SM Sourcing

Baimail, Konabari, Joydevpur , Gazipur

23 July 2023

Observations

Shed-1,2,3

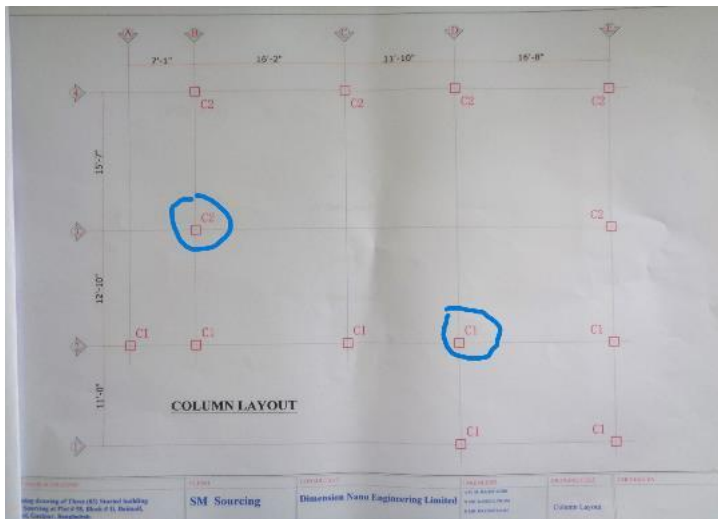
Building permit drawing was not available for the mentioned structure. The factory is required to collect building permit from BNBC prescribed local building permit authority.

Column layout

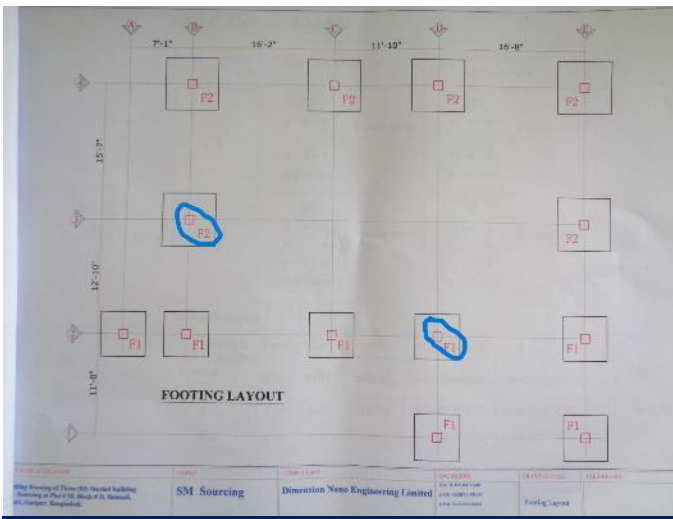
Cursory calculation indicates that the Stresses in the columns and foundations of the building are above the design limit, and the factor of safety is below 1.5 considering 2 kPa floor live load and equivalent material strength 13.1 MPa from concrete core test reports and ultimate bearing capacity 3.24 ksf from soil test report. The columns and foundations are highly loaded from peripheral brick walls and rooftop water tanks. Also, the concrete strength and soil bearing capacities are very low. The factory is required to reduce floor live load to 1 kPa and maintain until completion of Detail Engineering Assessment (DEA) as well as suggested remedial works. Verify in-situ soil bearing capacity by further testing and incorporate the test result in DEA.

Source of Loads: Brick walls and water tanks

Column layout: Marked column not shown in drawing

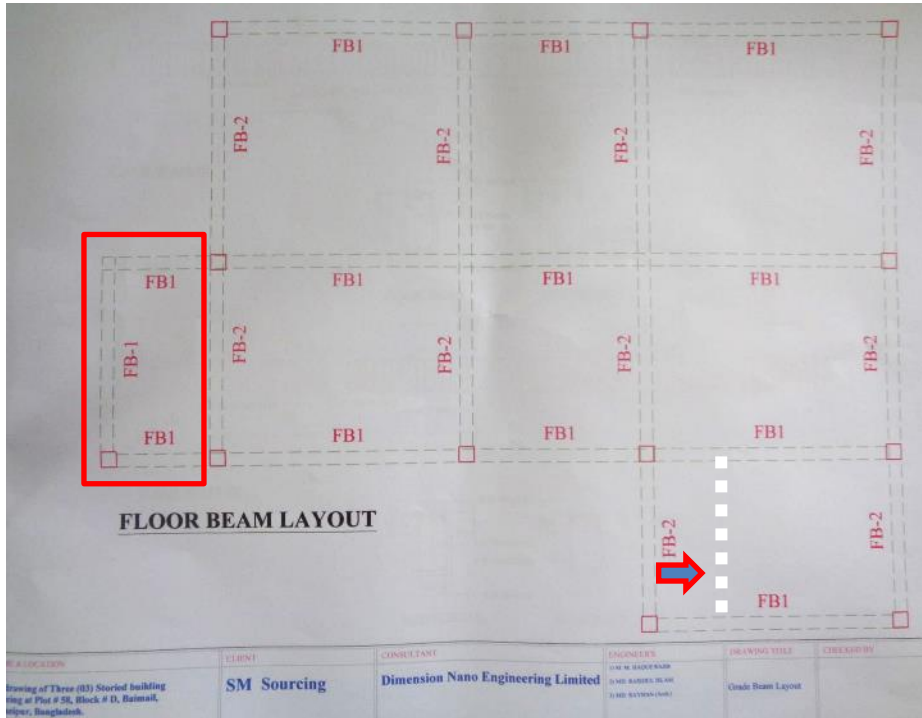
Column of porch not align with main building column grid. But drawing shown along the same column grid of main building.

Column built up-to ground floor roof

Column layout, size and rebar number didn't match between provided drawing and as-built condition. The marked column built up-to ground floor roof which was not shown in column layout; all the column sizes were found 250x250 mm instead of 375x375 mm; and only 4 rebars were found in column by scanning where drawings shown 6 & 8 rebars. Also, mismatch was found in column grid dimension.

Column rebar: 4 numbers instead of 8

Column size: 250 mm instead of 375 mm

Beam layout: Red marked beams were not found onsite. And white marked beam was found shifted.

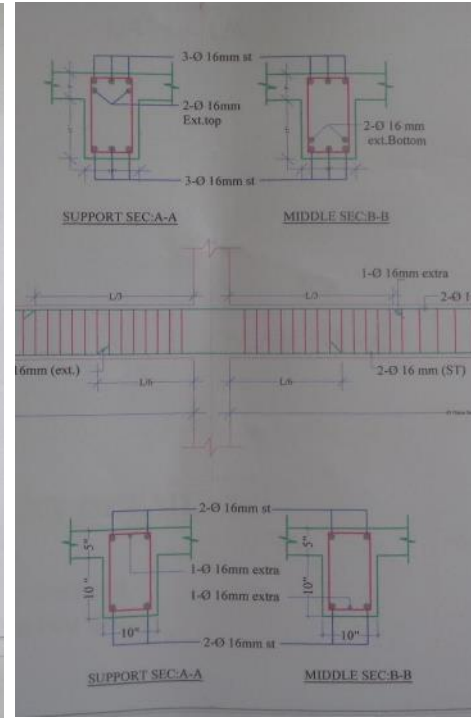
The beam layout and beam sizes were not matched with the provided drawings.

Beam depth in drawing:
 FB-1 = 500 mm
 FB-2 = 375 mm

Building engineer is required to survey the structure and prepare accurate as-built drawings and submit to the RSC for review.

Permit drawing

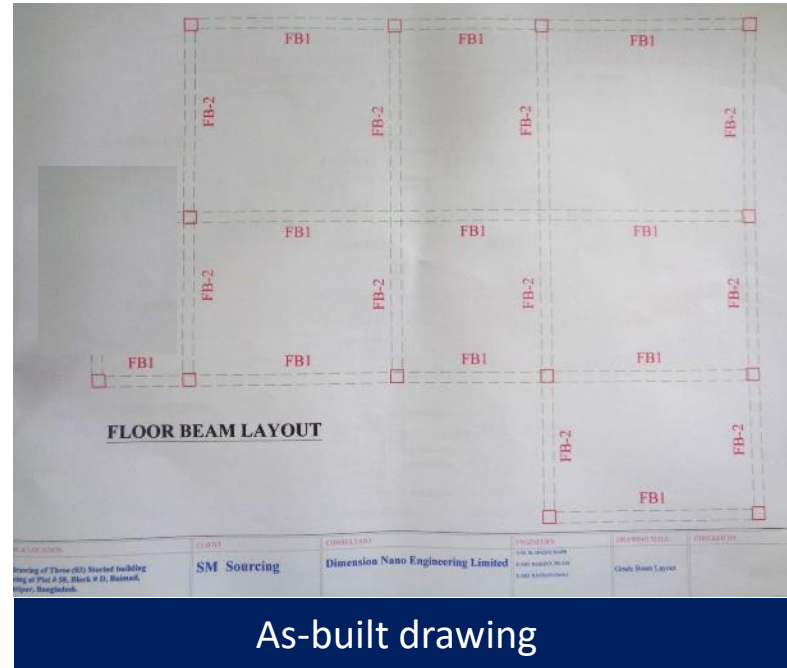
The as-built construction did not reflect the permit drawing. The number of beam & column and the floor layout was not matched with permit drawing. The factory is required to collect building permit from BNBC prescribed local building permit authority.

Lack of lateral stability of roof truss

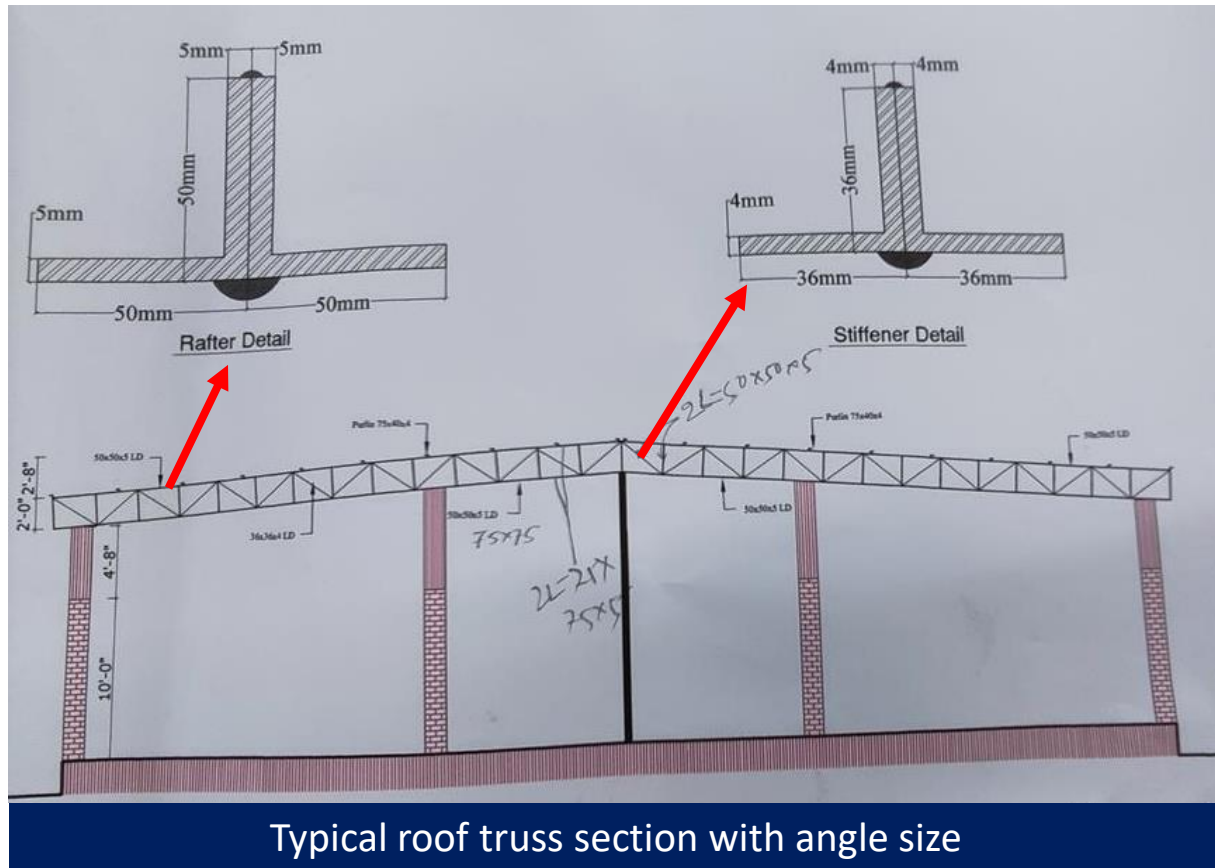
No load transfer media & bracings at roof

Improper connection between RC column and steel roof truss

No bracing system was observed along transverse direction of roof truss. Also, the connection between RC column and steel roof truss was improper. The building engineer is required carry out Engineering Assessment (EA) to check the connection & lateral stability of the structure and suggest proper remedial actions accordingly. Submit the EA documents to the RSC for review.

Lack of lateral stability of roof truss

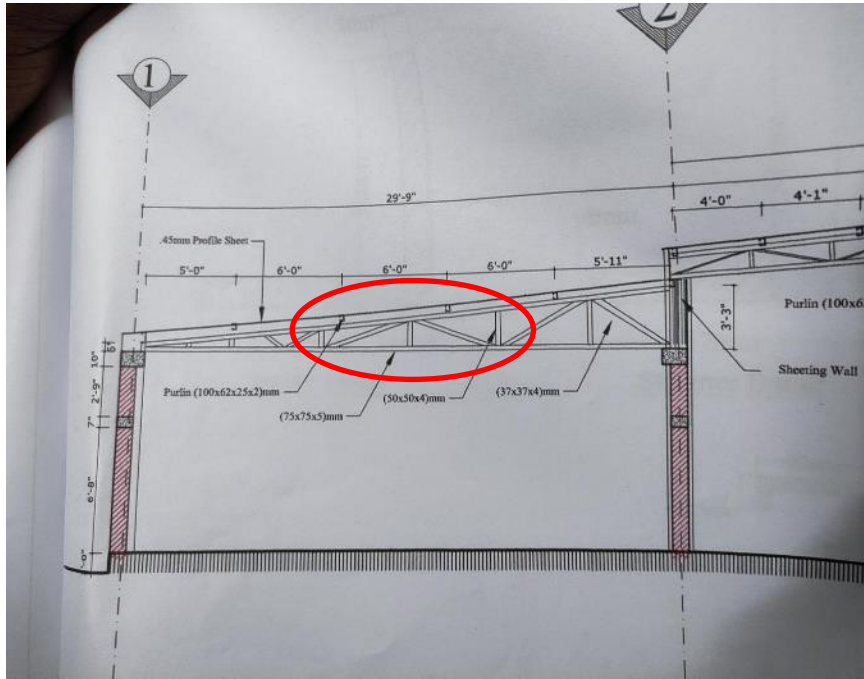
No load transfer media & bracings at roof

Improper connection between RC column and steel roof truss

No bracing system was observed along transverse direction of roof truss. Also, the connection between RC column and steel roof truss was improper. The building engineer is required carry out Engineering Assessment (EA) to check the connection & lateral stability of the structure and suggest proper remedial actions accordingly.

Tie Beam Layout Plan

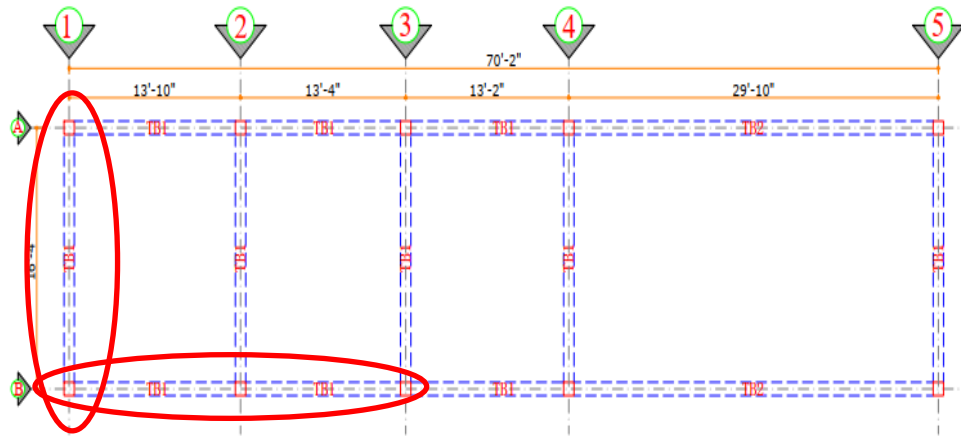
Tie Beam Layout (as-built drawing)

Tie Beam missing (on-site condition)

Some tie-beams were found missing on-site. The building engineer is required to survey the structure and prepare accurate as-built drawings.

Improper connections

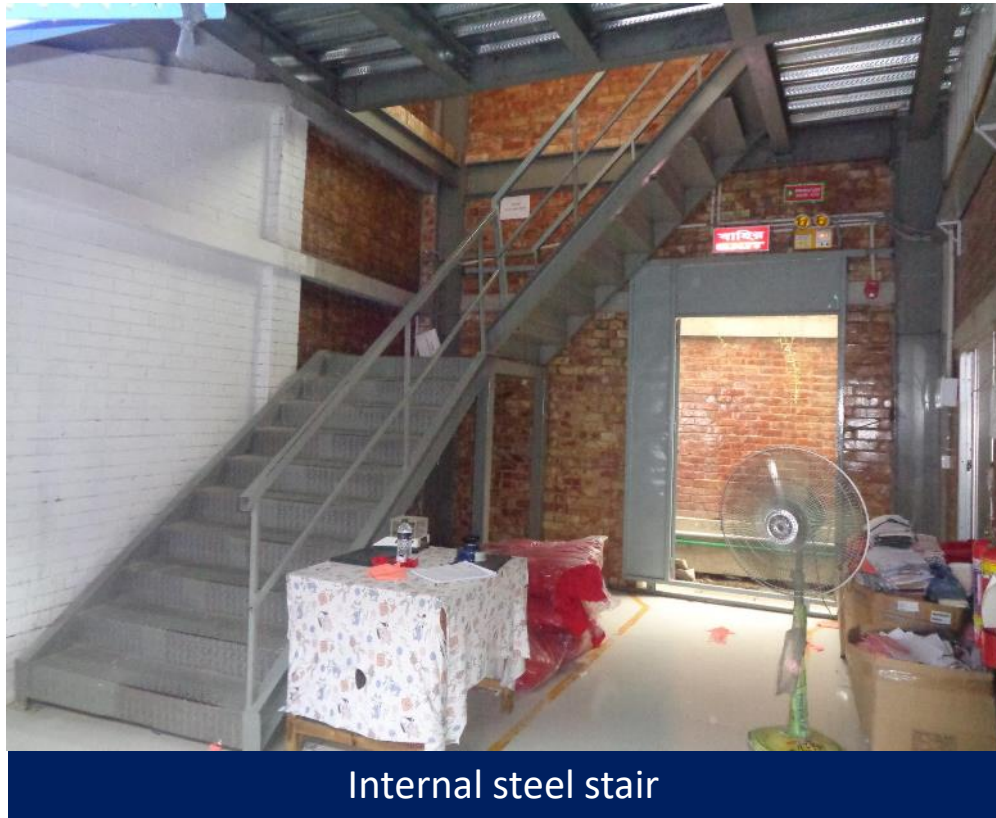
Large gap between end plates

Stair rested on a thin plate leg

Less contact surface of connection

Large gap between end plates

Haunch ends not connected to beam & column flanges

Gap between web & baseplate

Several improper connections were observed in the steel structure. The building engineer is required to check the connections and suggest proper remedial actions to make the connection active & adequate.
